## ADDENDUM IDAP REPORT

<b>Property:</b>	14 Amaroo Avenue STRATHFIELD Lot: 63 DP: 35995 DA2021.294
<b>Proposal:</b>	Demolition of existing structures, construction of a two (2) storey dwelling house with basement level, front fence, attached shed and ancillary landscaping.
<b>Applicant:</b>	T Taouk
<b>Owner:</b>	R Magale
<b>Date of lodgement:</b>	12 November 2021
<b>Notification period:</b>	19 November 2021 to 3 December 2021
<b>Submissions:</b>	1
<b>Assessment officer:</b>	G Choice
<b>RECOMMENDATION OF OFFICER:</b>	REFUSAL

Figure 2: Amended basement plan 1364 – 01 Rev. C

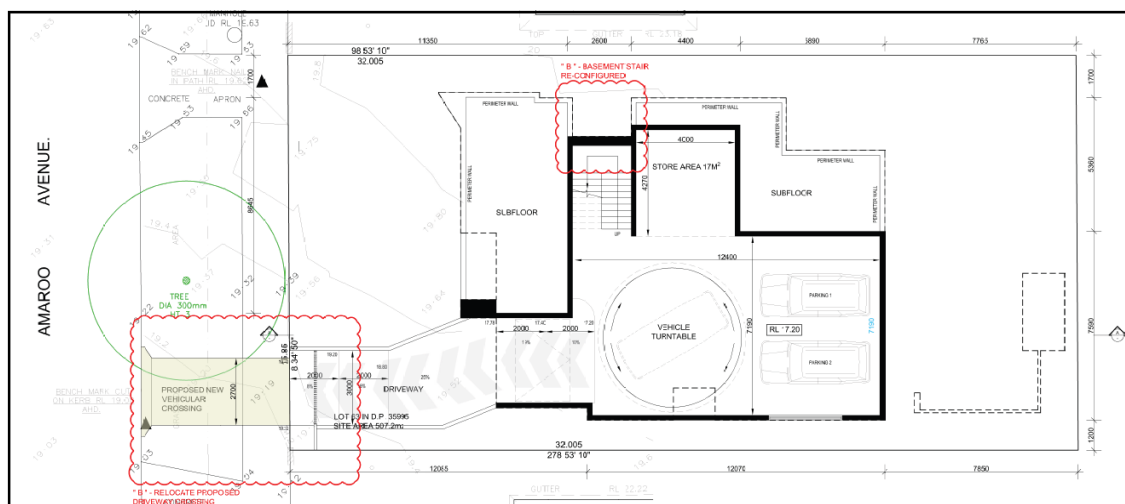
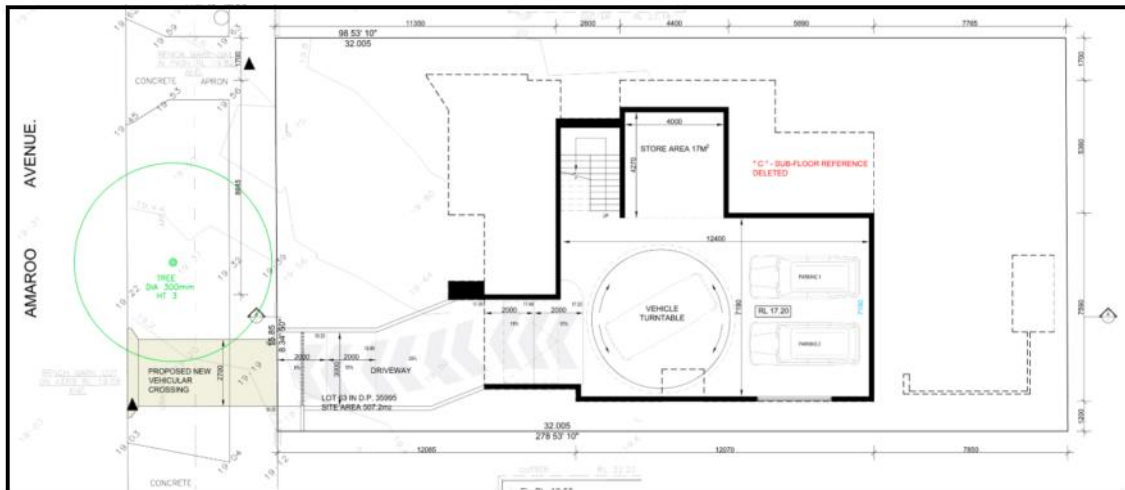
- 30 May 2022      Recommendations for additional amendments were provided to the Applicant (based on IDAP comments) as follows:
- i.      **Basement**
    - All references to the sub floor/perimeter wall outline from the basement plan were to be deleted.

- Deletion of sub-floor annotations.

Reference labels to the sub floor and perimeter wall outline have been deleted and replaced with a single dashed line to indicate the ground floor footprint. Although, this is not a complete removal of the ground floor footprint or indicative of a sub-floor wall, plans could be further redacted via condition with any consent.

Figure 6: Amended first floor plan 1364 – 02 Rev. C

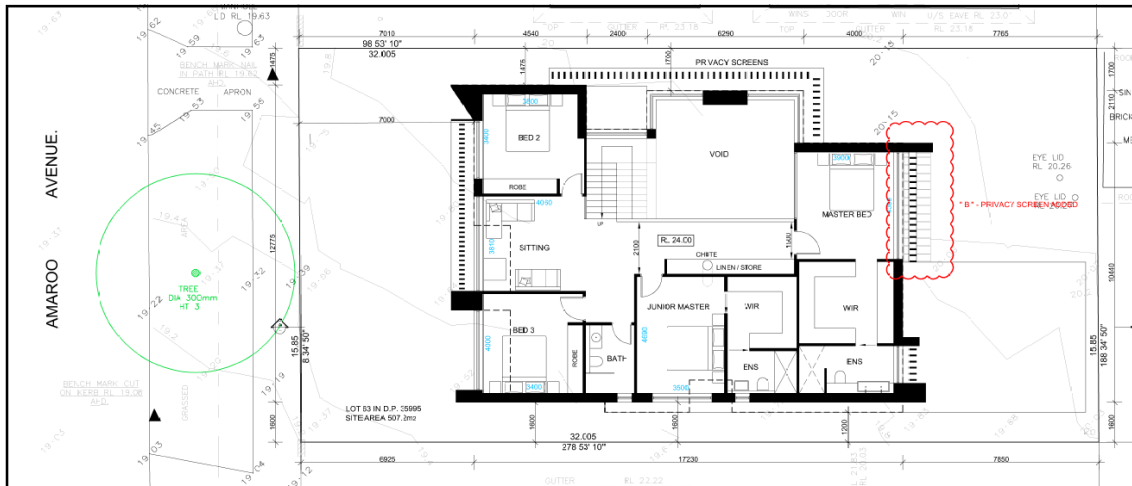
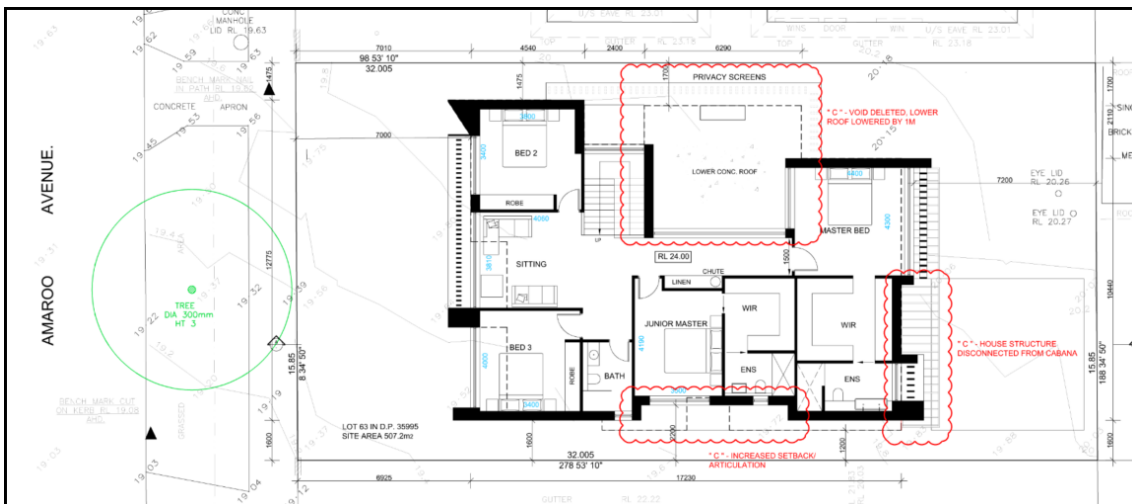
- ii.     **Bulk and Overshadowing**
    - The large first floor void was not supported as it contributed to bulk and unnecessary overshadowing of the southern adjoining property at 16 Amaroo Avenue. It was recommended that the void be deleted from the plans. The first floor layout was to be reconfigured to reduce bulk form the southern boundary. Possible options included (but were not limited to) shifting the Master en suite and WIR into the void space; or shifting the Junior Master with WIR and en suite north into the void space.

- Increase southern side setback with 600mm cut-in of southern elevation and reduction of Junior Master floor area; and
- Void roof lowered by 1m to create coffered ceiling.

The large first floor void has not been deleted as per the recommendations of IDAP. Instead, the Applicant has lowered the void ceiling by 1m to create a coffered ceiling effect. It is noted that this design change does enhance articulation to the dwelling frontage. Additionally, the first floor southern elevation includes a 600mm cut-in and reduction of Junior Master floor area to create greater articulation at the first floor along the southern boundary. The proposal will result in a void space providing a floor to ceiling height of 5.5m contrary to Section 4.2.2 of Part A of the SCDP 2005. This does not adequately reduce the bulk of the first floor plan as raised in the IDAP review.

Figure 12: Amended shadow diagrams at 9am winter

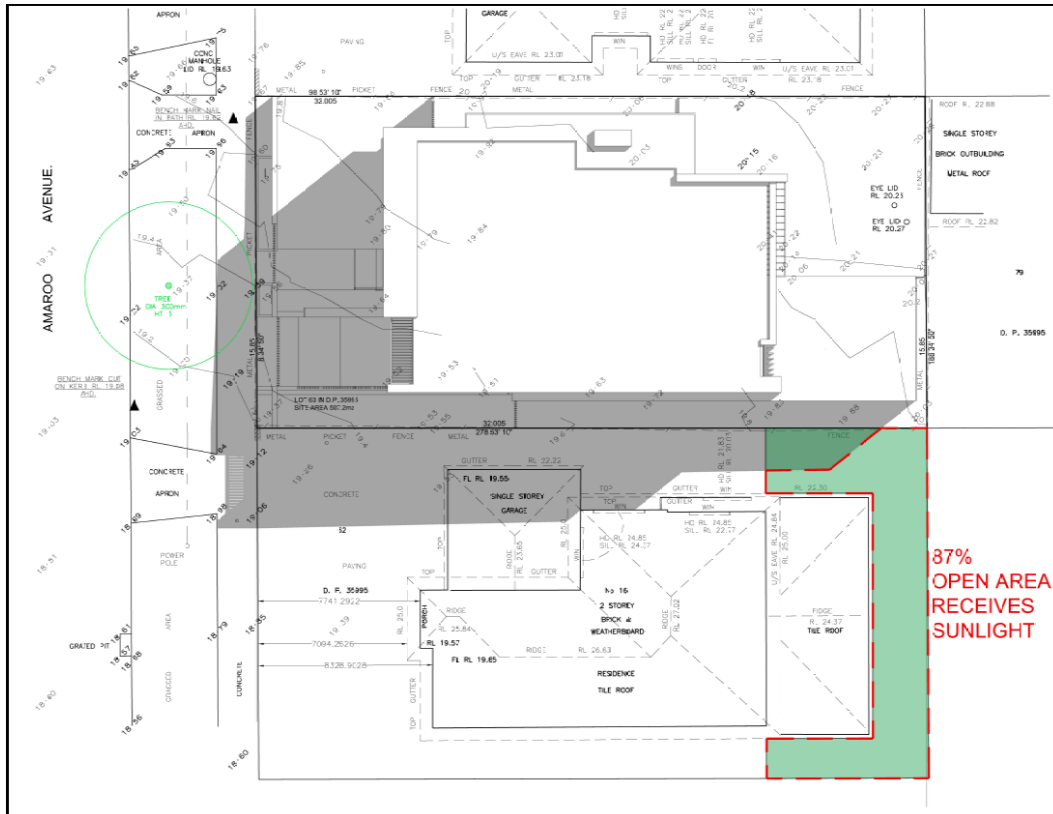
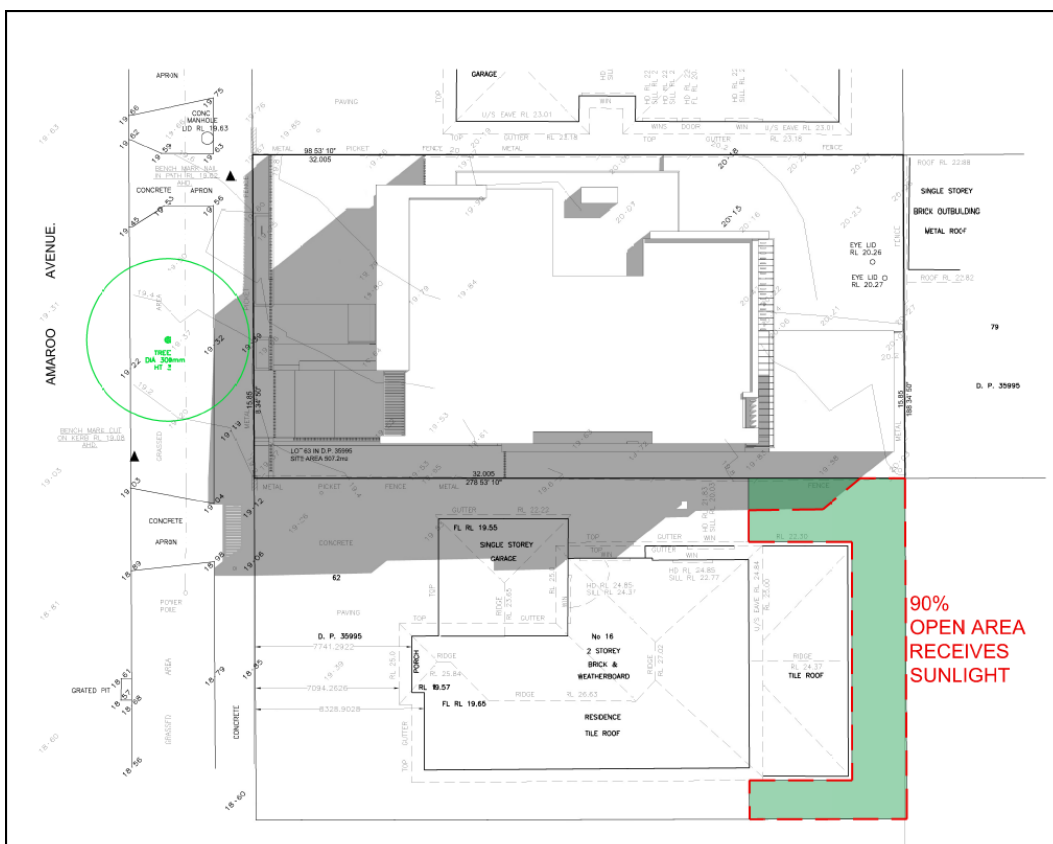
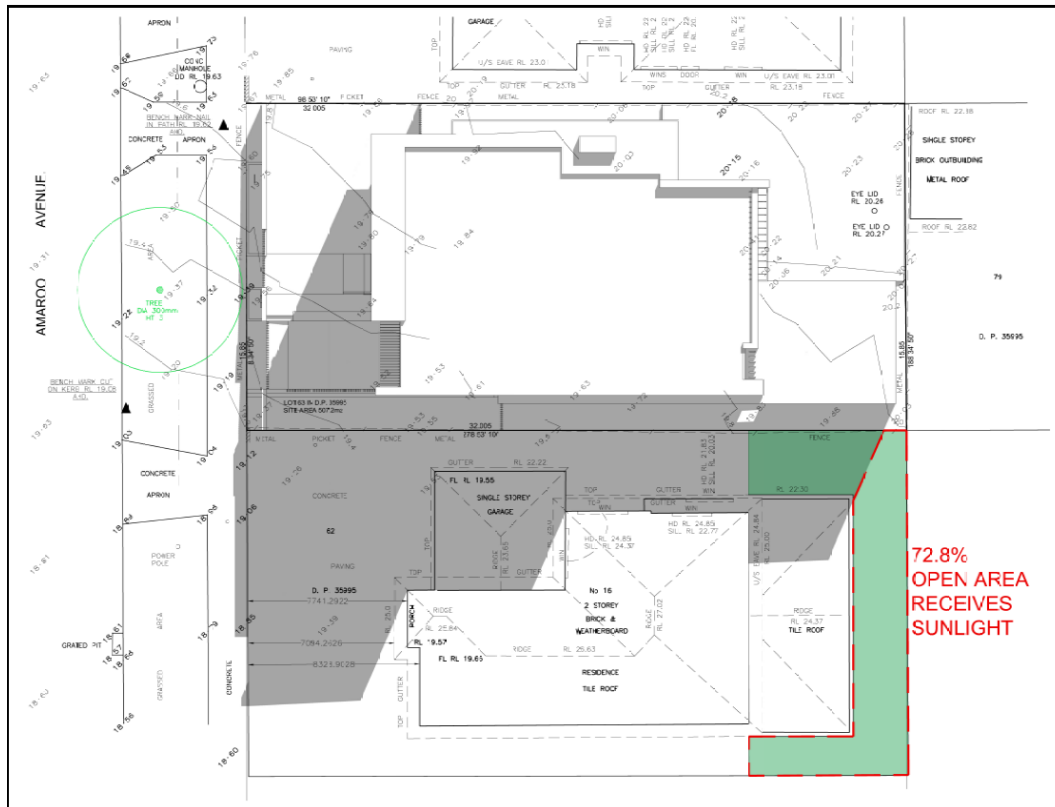
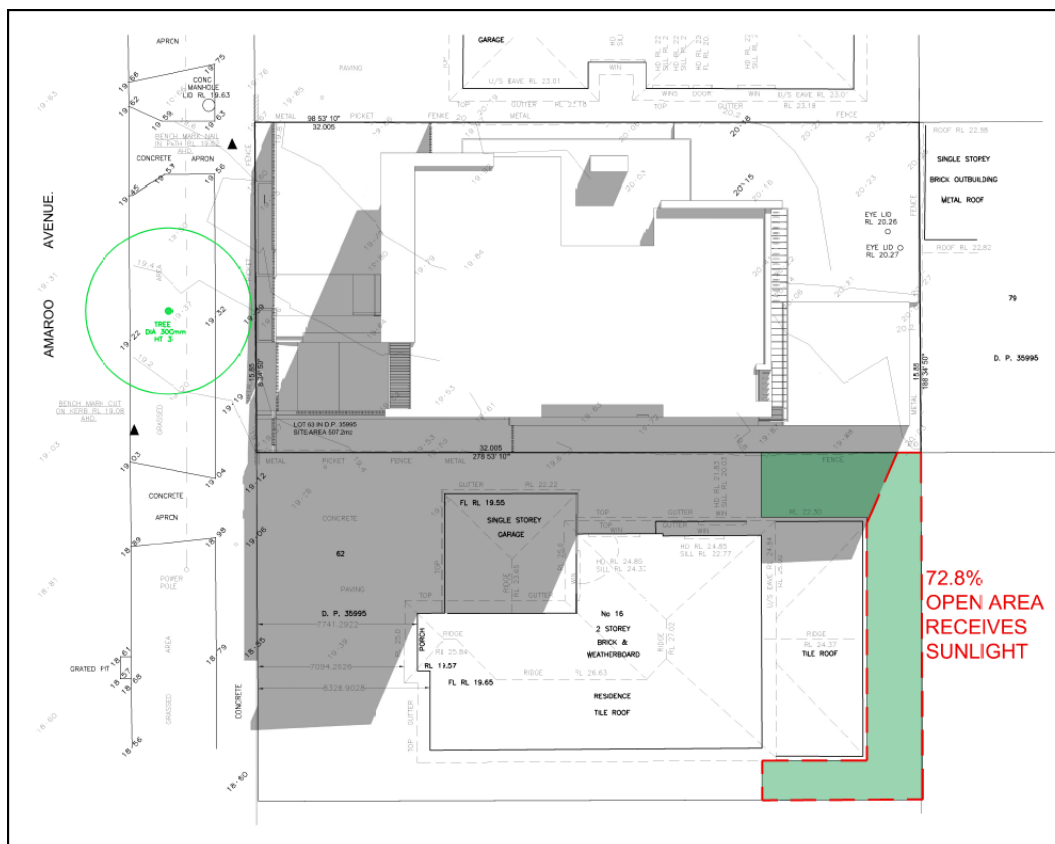
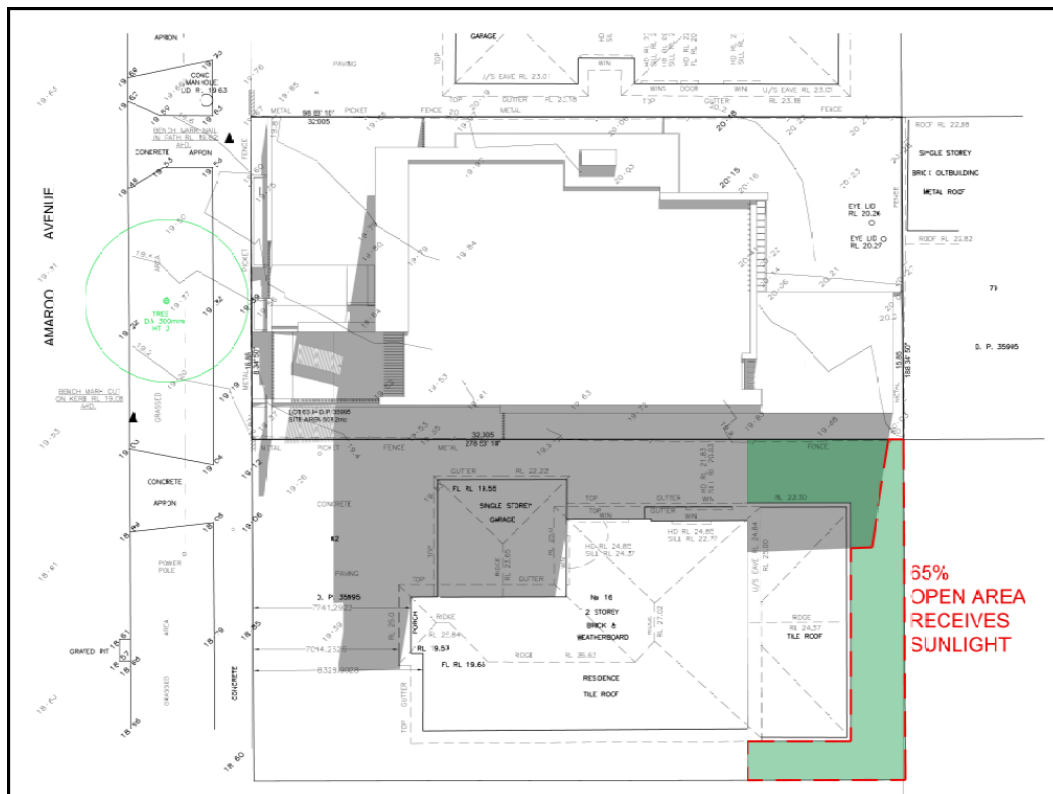
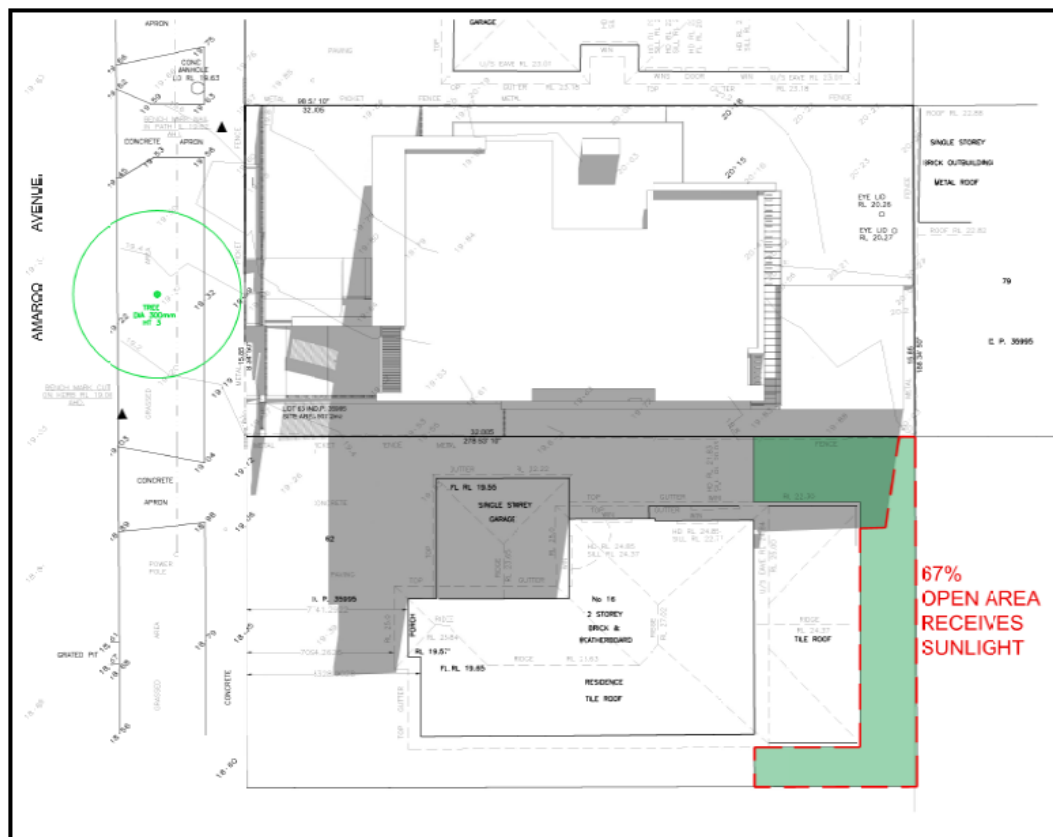
Amended shadow diagrams show a marginal increase in solar access to the north-east bounds of the rear yard at 16 Amaroo Avenue (see **Figure 11** to **Figure 24**). It is considered the proposed development (as amended) does not reflect the recommended design changes as per the IDAP comments and the issues raised by the IDAP with regard to bulk and overshadowing have not, therefore, been adequately addressed.
